**CITY OF TEMPE
DEVELOPMENT REVIEW COMMISSION**

**Meeting Date: 11/18/2014
Agenda Item: 4**

ACTION: Request for a Use Permit to allow a bar in the CC (City Center) zoning district and a Development Plan Review consisting of building and patio expansions and modifications to an existing building, including exterior televisions, glass paneled roll-up garage doors, and a patio screen wall for WHISKEY ROW, located at 640 South Mill Avenue, Ste. 120. The applicant is AV3 Design Studio.

WHISKEY ROW

FLOOR PLAN
SCALE: 1/8" = 1'-0"

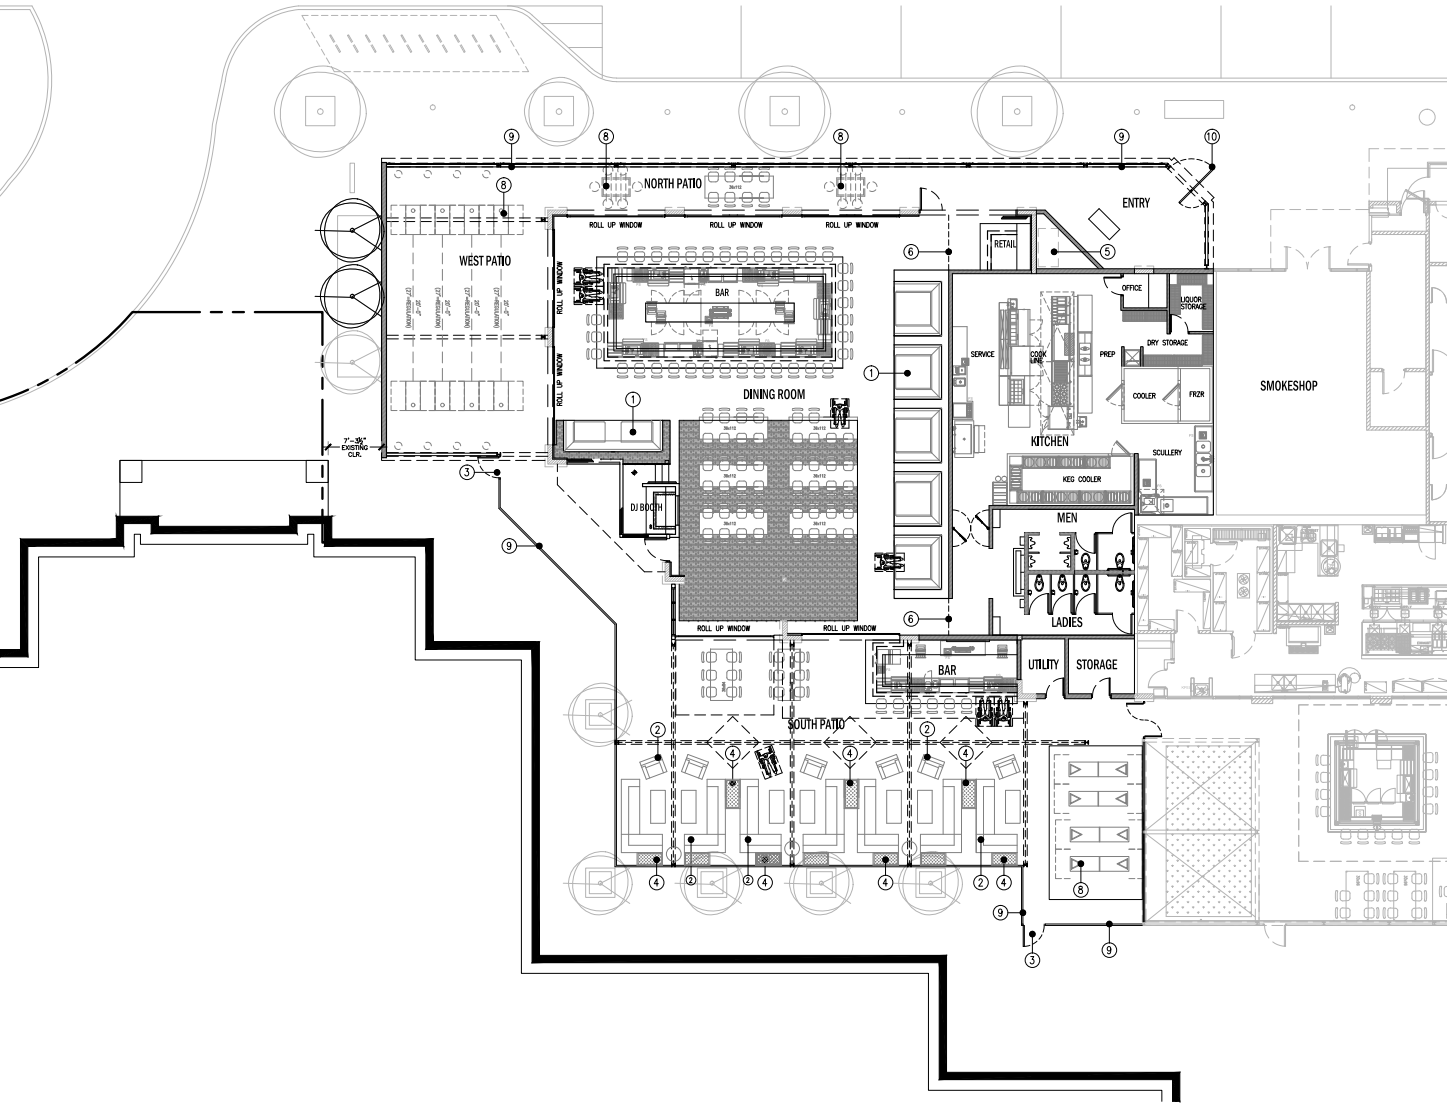
11. Correct key note 8 to identify the tables on the north patio as tables instead of games.
12. Public Restroom Security:
 - a. Lights in restrooms:
 - 1) Provide 50% night lights
 - 2) Activate by automatic sensors, key or remote control mechanism
 - b. Single user restroom door hardware:
 - 3) Provide a key bypass on the exterior side

NORTH ELEVATION
SCALE: 1/4" = 1'-0"

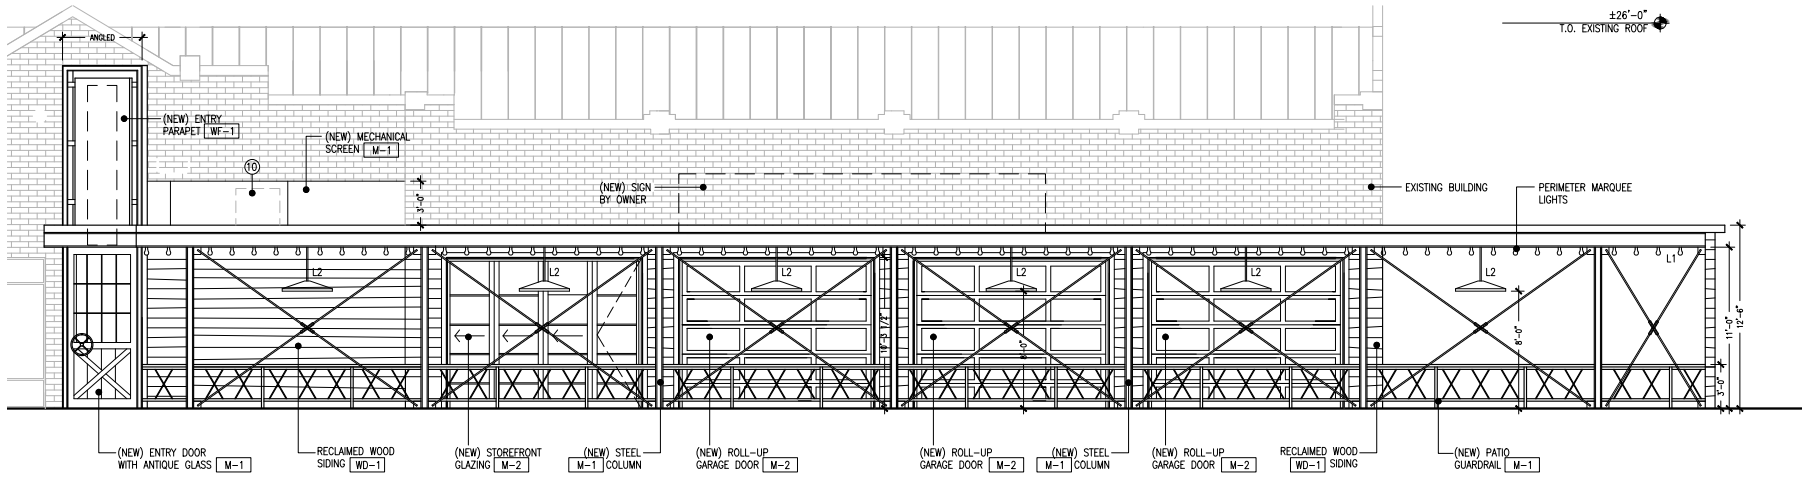
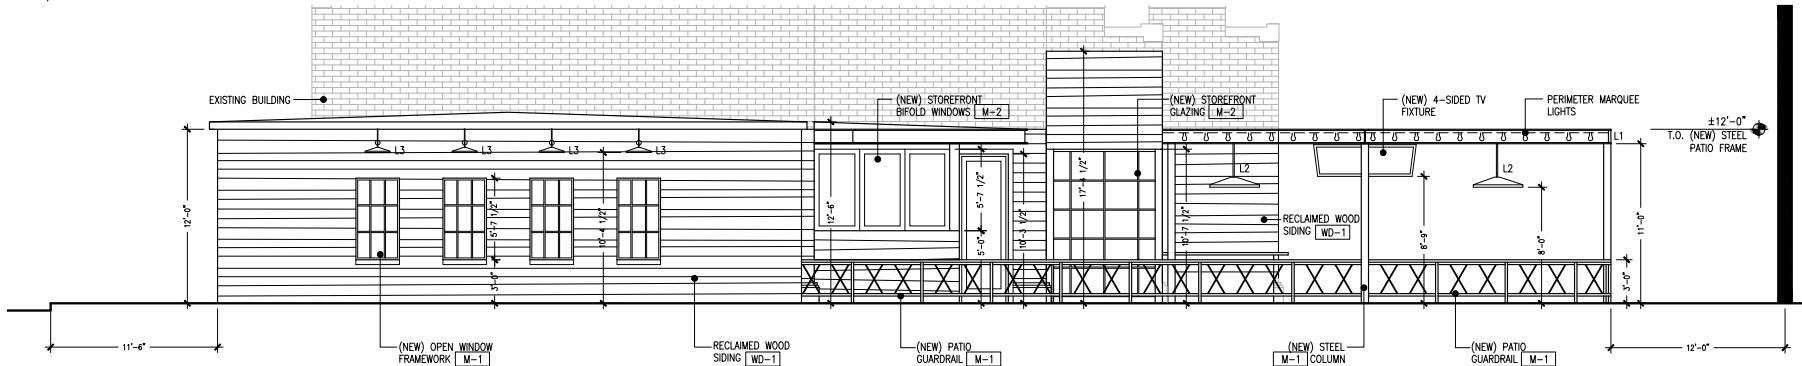
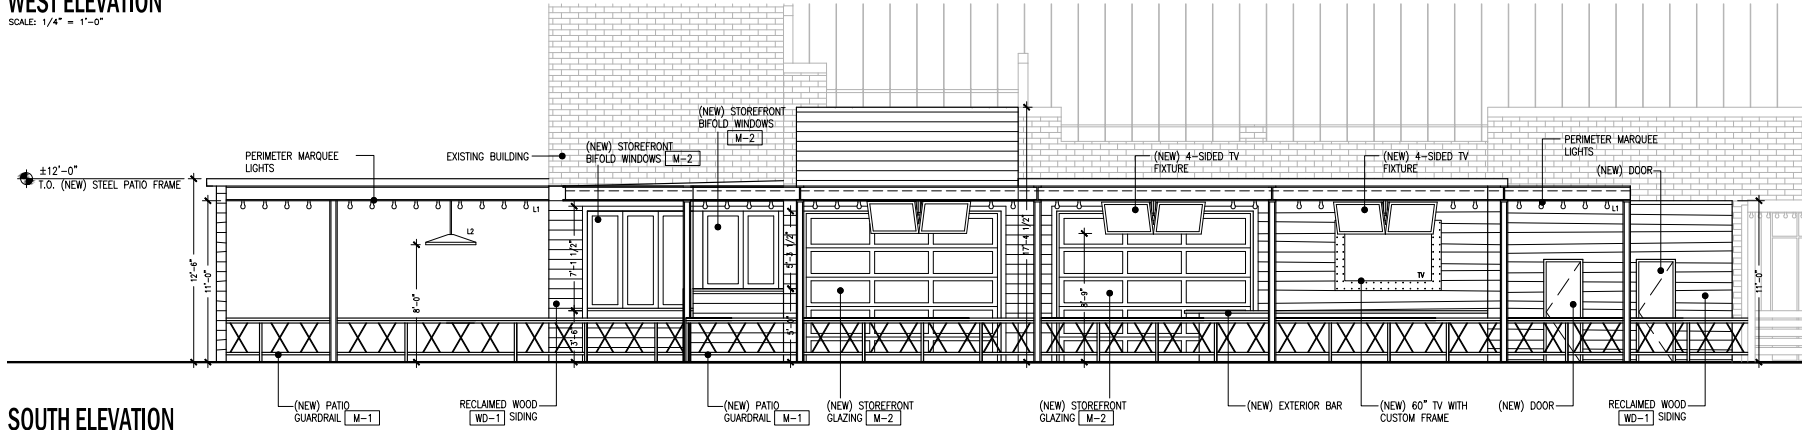
14. The Gray/Black Mix Reclaimed Lumber siding is not approved as part of this application. Please submit a revised material to Planning Division staff for approval. The material shall be a hard wood and must be treated to resist UV damage.
15. Artificial ivy is prohibited on the exterior of the building. This includes the ivy proposed over the new entrance parapet. This excludes the ivy on the east side of the west patio wall.
16. Provide sound insulation on the east side of the west patio wall.
17. Provide insulated windows in the west patio wall where elevations identify “open window framework.”
18. Conceal roof drainage system within the interior of the building.
